WATER QUALITY MEMORANDUM

Utah Coal Regulatory Program

RE: Fourth Quarter of 2013 Water Monitoring, Alton Coal Development LLC, Coal Hollow, C/025/0005, Task ID #4469

Figure 1. Well Y-102: Alluvial well in upper Sink Valley to the east of pit 9 in permit area.

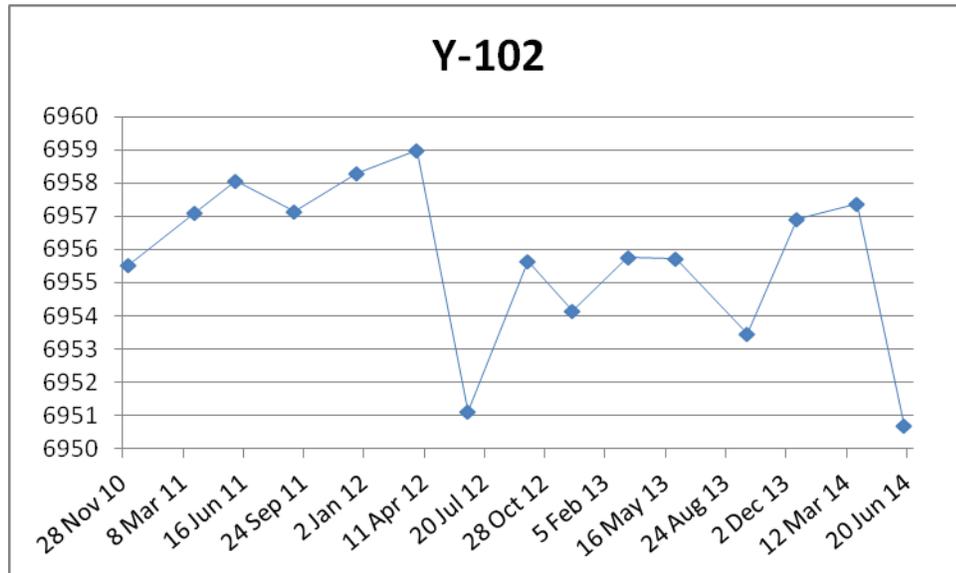
None, however tracking the water elevation in well Y-102 would be worth continued examination. Monitor elevated selenium in SP-33, SW-2, SW-3, LS-28, and Y-61.

Figure 2. Elevated Selenium levels at five sampling locations in Q4 2013 and Q1 2014. (Values of 10 ug/l were entered at >20 ug/l into the monitoring database. They were given a consistent low value in order to graph the data.)

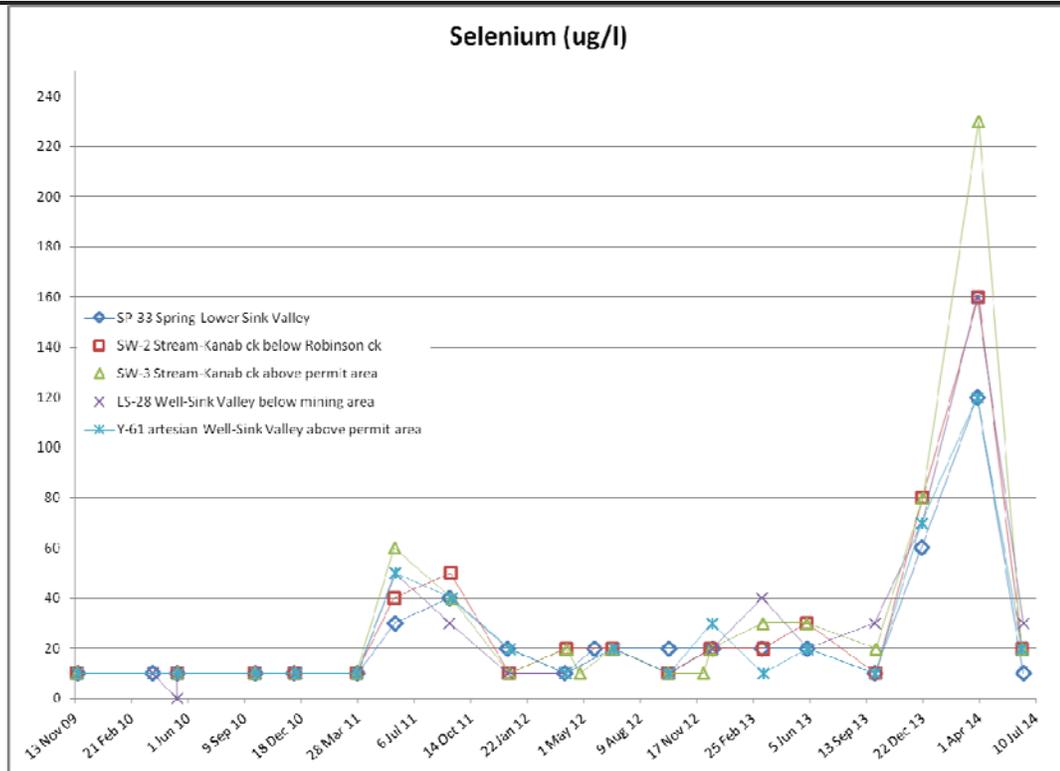
SP-14 December – T-Alk, Bcrb CaCO₃, D-CA, D-MG, T-Cats
SP-20 December – total alkalinity, bicarbonate, total anions, cation-anion balance
SP-33 December– T-Se is fairly high at 60 ug/l

BLM-1 December – dissolved calcium
SW-2 December – T-Alk, Bcrb CaCO₃, T-Se at 80 ug/l
SW-3 December – T-Se at 80 ug/l

LR-45 December – total alkalinity, Bcrb CaCO₃, total cations
LS-28 December – T-Se at 70 ug/l
SS-30 December – dissolved calcium, dissolved sodium
UR-70 December – total dissolved solids
Y-61 December – T-Alk, Bcrb CaCO₃, T-Anions, Cat-Ani, T-Se at 70 ug/l
